No critical dimension difference between Ubot and current ITW tray on X-Y plane.

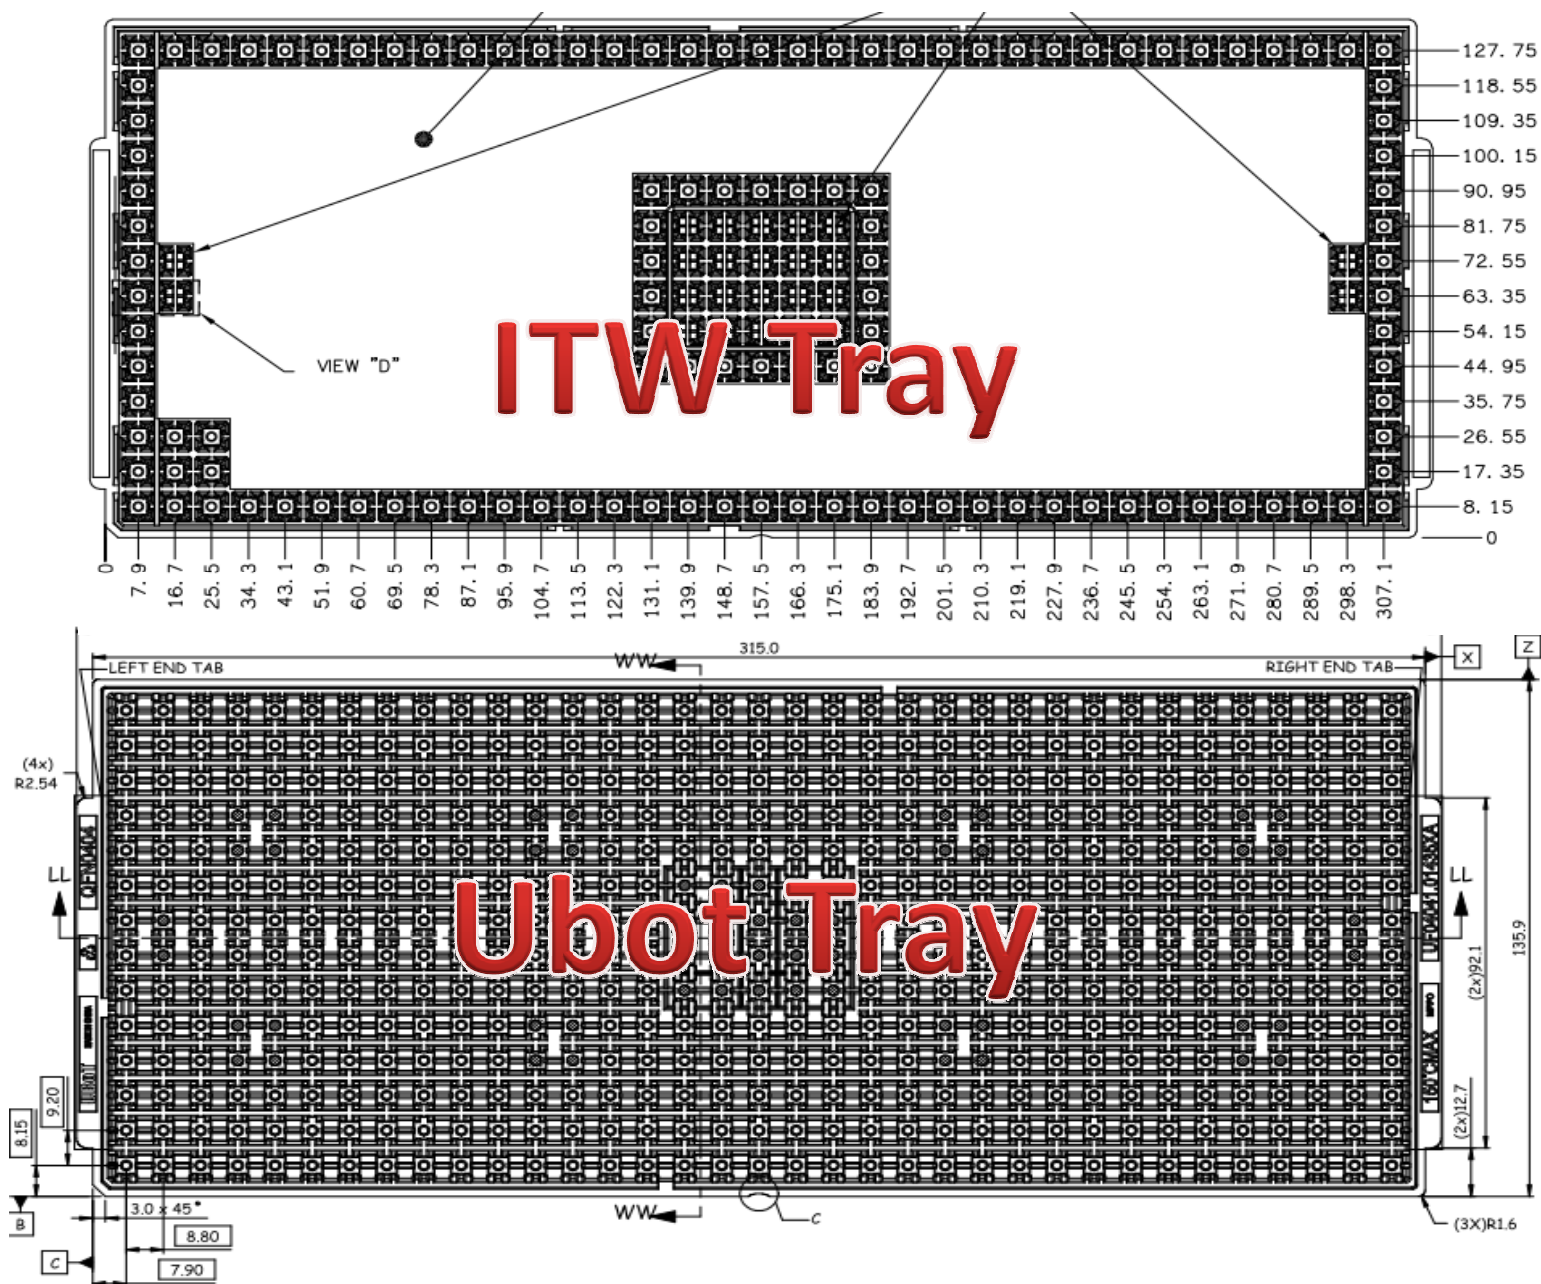
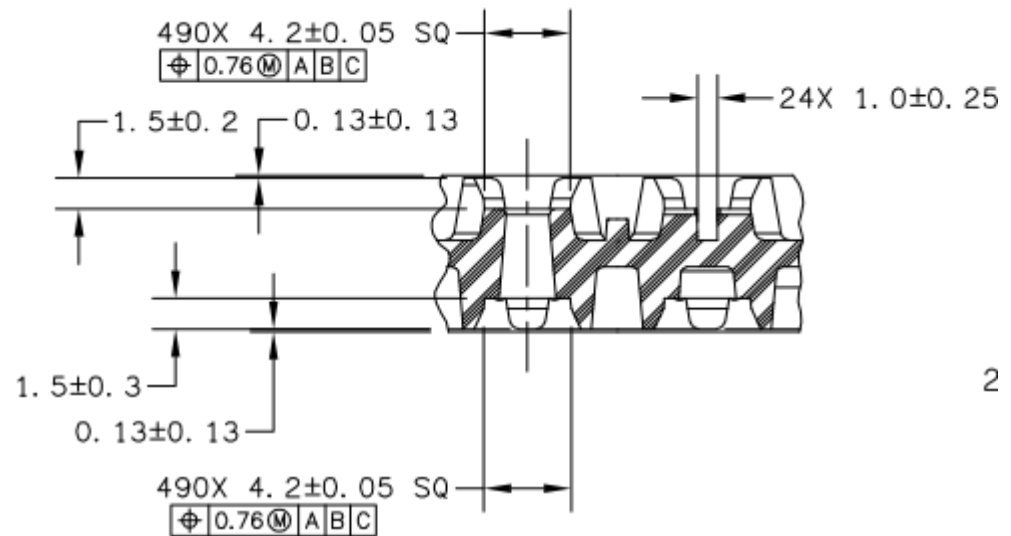
The current ITW tray's pocket depth is 1.5mm, and Ubot is 1.8mm.
